Convent of Mercy Gravesend planning ref 20241161: Sketch and photograph responses to objection letter

Version 2 3/03/2025

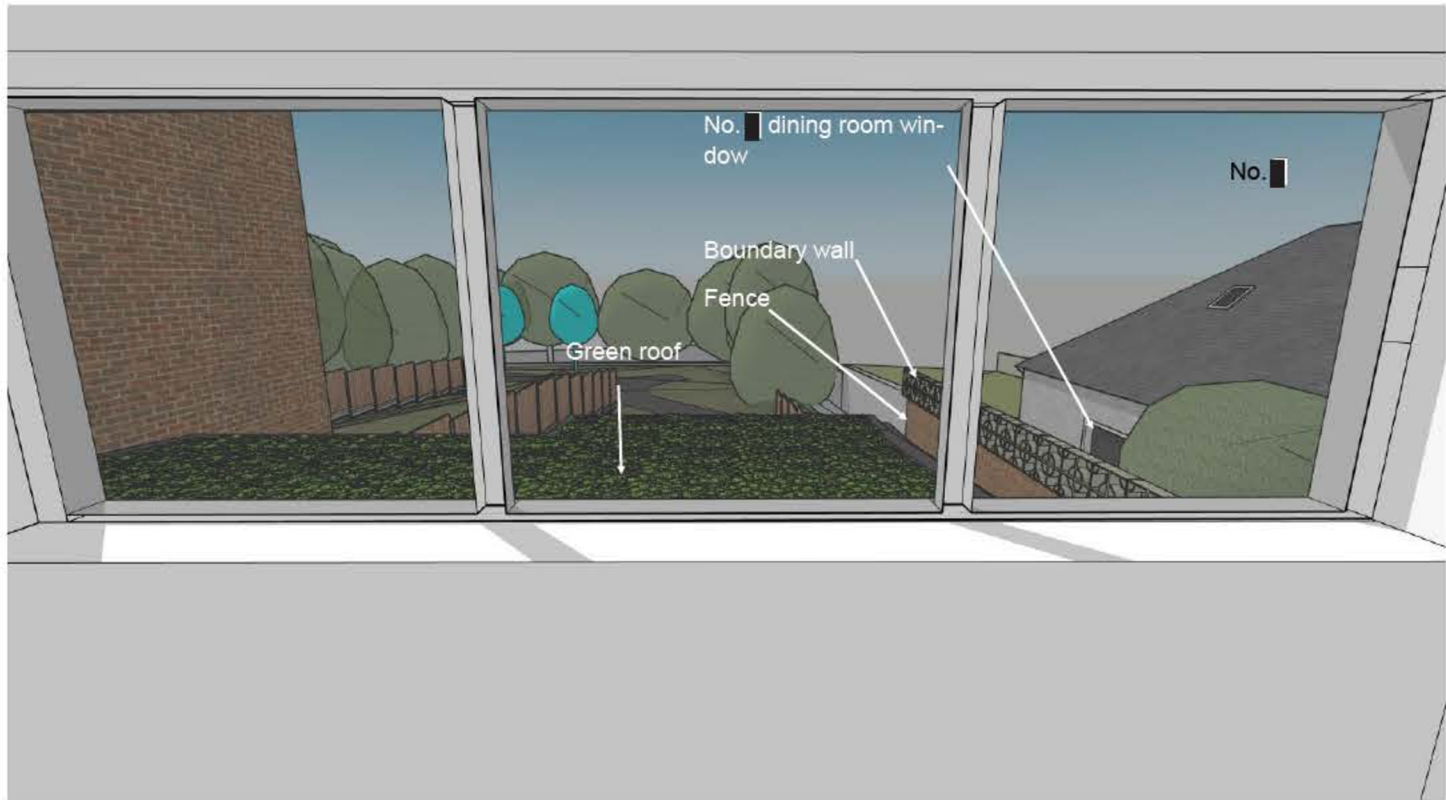
The area north east of no. [redacted] is in shadow most of the day. The proposed bungalow sits within this area and will have minimal impact on no. [redacted], which is south of this shadow area, if at all
